# Spartan Fire, LLC

Campaign Service Bulletin  
CSB21-350-001

**CONDITION:** Rear Neway ADZ-127 suspension label has incorrect weight rating

**FIG. 2.1**

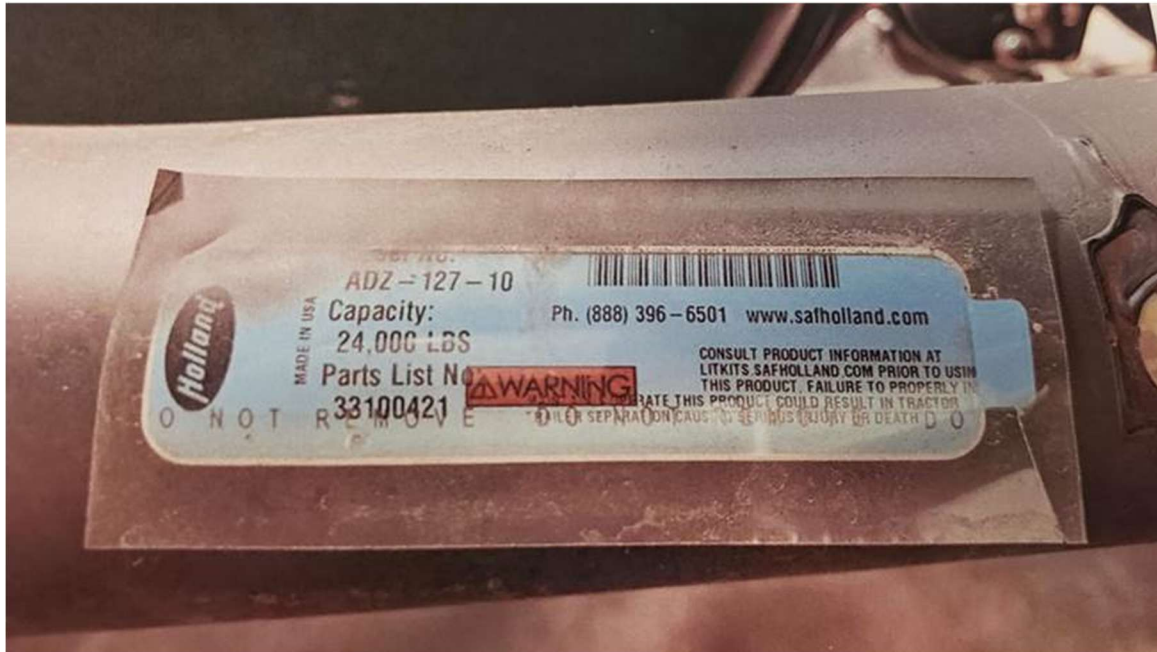
1. Locate suspension label on rear suspension lower control arm. *See Figure 2.1*

2. Examine label capacity on original label.
  - a. If capacity indicates 27,000 lbs, no further action is needed. The label is correct.
  - b. If capacity indicates 24,000 lbs as shown in figure 2.1, then proceed to step 3.
3. Identify if original label contains a part number 33100421 or 33100426
4. Select the new label with the same part number as the original label.
5. Remove original label from control arm and dispose of properly.
6. Clean area with a wax and grease remover to ensure proper adhesion of the new correct label.
7. Remove adhesive backing from new label and carefully apply to the clean region, pressing firmly to ensure proper adhesion.

**CORRECTION:** Replace incorrect 24,000 lb labels with 27,000 lb labels.
